TRUSSES T-1 & T2

NAVAL AIR STATION
SEATTLE, WASHINGTON
59'-0 & 75'-0 TRUSSES
A & R BUILDING # 5A

151-B-S5

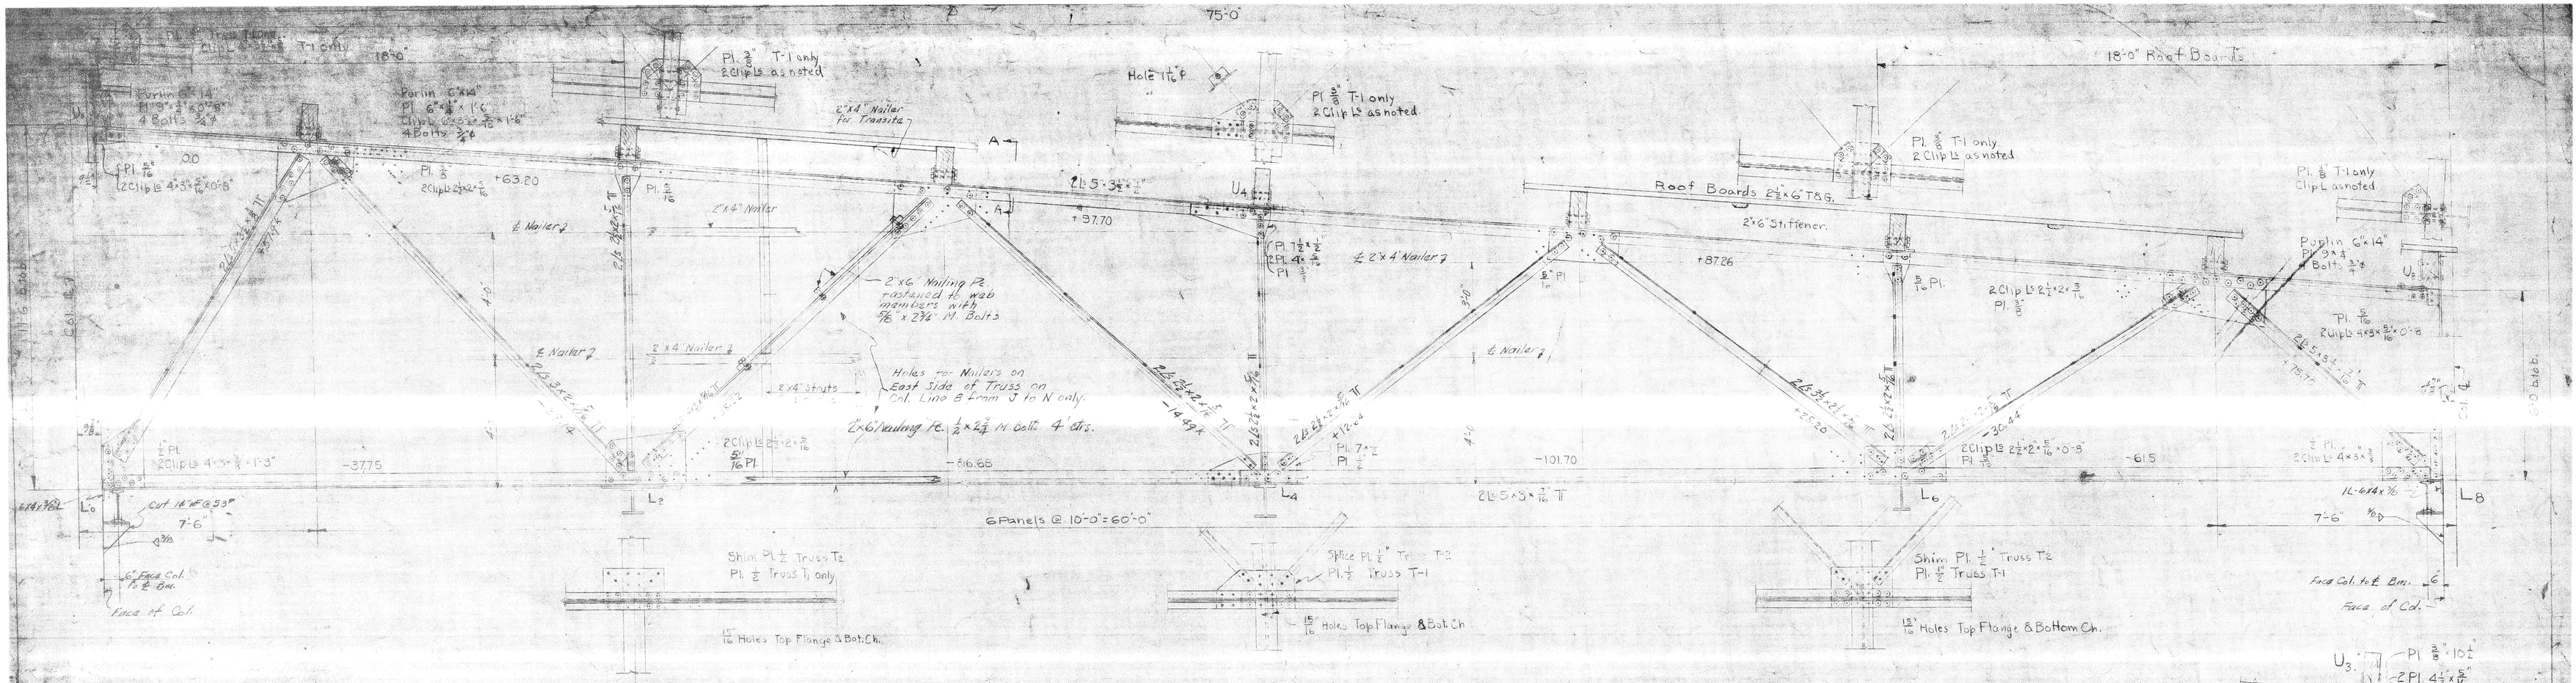
ADDITIONS: CHANGE TRUSSES ON LINES 8, 9, & 10, N TO J.

75' TRUSSES ON COL. LINES 3 & 4

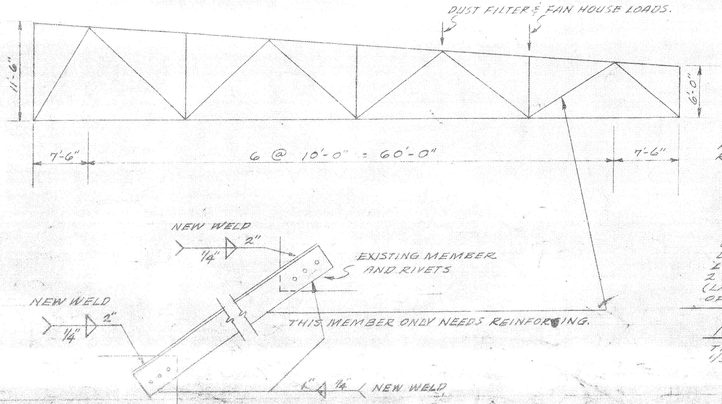
NECESSARY REVISION TO TAKE CARE OF DUST FILTER AND FAN HOUSE TO BE INSTALLED ON ROOF OF A & R BLDG. EXTENSION.

DEAD LOAD, 20 #/□' ROOF LIVE LOAD, 11,325 # AT EACH OF TWO PANEL PTS. AS SHOWN ON SKETCH, DUE TO DUST FILTER AND FAN HOUSE, AND A MOVABLE 2 TON OR 5 TON FROM THE 5 TON MONORAIL CRANE. A TON CRANE AND SUSP. CEILING (ORIGINAL DESIGN CONDITIONS ELIMINATED) ARE NOT INCLUDED IN DESIGN LOADS OF THIS TRUSS.
